Operational Noise – Joint Response on behalf of the Applicants to DPEA Procedure Notice dated 30th June 2023

Date: 21st July 2023

Conjoined public inquiry concerning:

WIN-370-4 / WIN-370-5 / WIN-370-6

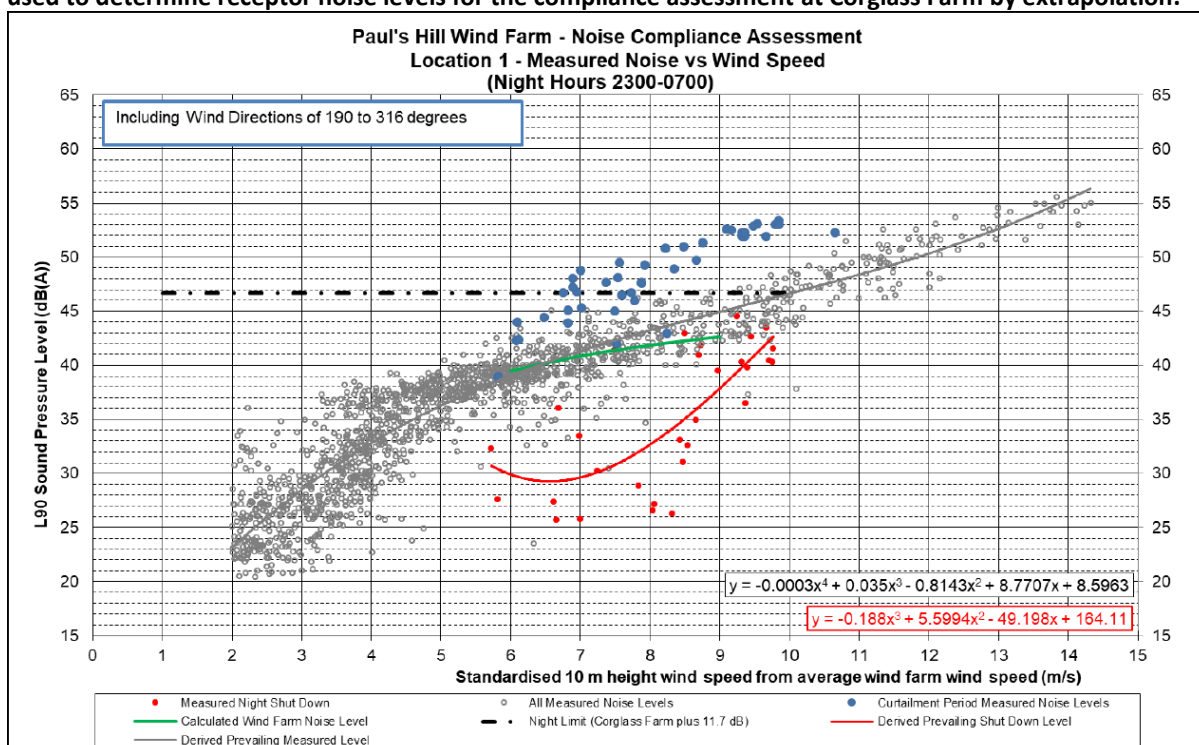
Table 1 below). A further submission (see ANNEX B¹⁴) to the PH2WF appeal provides a chart highlighting the data where constraints were used (see Figure 1 below). This chart shows a specific trend of data much higher than data related to normal operation and the tabular values indicate that at wind speeds of 8 m/s to 10 m/s the increase in noise levels is around 8 dB(A). Whilst the tabular data does not extend up to 12 m/s the trend of data for normal operation (Figure 1 green line) and non-normal operation (Figure 1 blue dots) appear to run parallel over the wind speed range of available data, indicating a similar difference is likely at 11 m/s and 12 m/s.

- 3.18 In the above example, the grey measurement dataset was obtained during ‘normal’ operation. The blue measurement dataset was obtained during active-stall regulated (i.e. non-normal) operation¹⁵. This confirms that when under active-stall (i.e. non-normal) regulation, the turbine type installed at HHWF generates significantly higher levels of noise than when operated under ‘normal’ operation.
- 3.19 It is understood that since approximately 2016/2017, the revised operational regime at HHWF is such that active-stall regulated operational is no longer applied during grid related energy export restrictions (i.e. non-normal operational is no longer used).
